Decision Report

Application for Works Approval

Works Approval Number W2995/2025/1

Premises Mt Ida Project

Figure 2: Cross-section of liner system

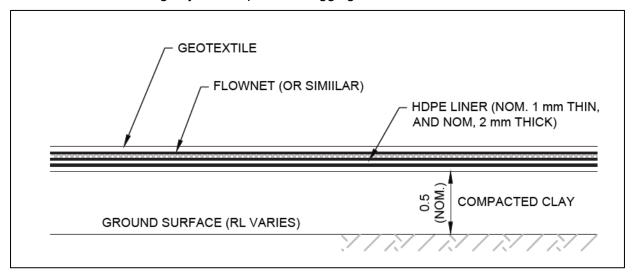
Commissioning and operation of the IWLTSF	Dust including tailings dust	Air / windborne pathway causing impacts to vegetation health	Surrounding native vegetation TEC 7km west of prescribed premises	Refer to Section 5.1	C = Minor L = Unlikely Medium Risk	Y	Condition 9, 10, 11, 13 and 15	N/A.
	Tailings supernatant containing acid, dissolved solids, metals and metalloids	Seepage to groundwater causing contamination and/or mounding causing impacts to native	Surrounding native vegetation TEC 7km west of prescribed premises	Refer to Section 5.1	C = Moderate L = Unlikely Medium Risk	N	Condition 2 Condition 13, 15, 17, 18 and 19	The delegated officer notes that the design does not include a protection geotextile between the aggregate and HDPE liner in the IWLTSF underdrainage trench. The delegated officer considers this an unacceptable risk where the liner may

Risk events					Risk rating ¹		Conditions ² of works approval	Justification for additional regulatory controls
Sources / activities	Potential emission	Potential pathways and impact	Receptors	Applicant controls	C = consequence L = likelihood	Applicant controls sufficient?		
		vegetation health						become damaged due to the friction between the drainage aggregate and the liner. The delegated officer has therefore added a requirement to place a protection geotextile between the HDPE liner and aggregate in the underdrainage trench.
		Direct ingestion			C = Moderate			
		by fauna impacting fauna	Native fauna	Refer to Section 5.1	L = Rare	Y	Condition 13 and 15	N/A
		health			Medium Risk			
		Overtopping of IWLTSF causing impacts to vegetation health	Surrounding native vegetation Drainage lines	Refer to Section 5.1	C = Moderate L = Unlikely Medium Risk	Y	Condition 13 and 15	N/A
Tailings delivery, IWLTSF underdrainage system and return water pipes	Spillage of tailings, leachate and return water through leaks, pipeline ruptures or failure	Direct discharge to land / overland run off causing impacts to vegetation health	Surrounding native vegetation Drainage lines	Refer to Section 5.1	C = Moderate L = Possible Medium Risk	N	Condition 2 Condition 9, 10, 11, 13 and 15	The delegated officer has included a requirement for pipelines carrying tailings or return water to have either a leak detection system or secondary containment.
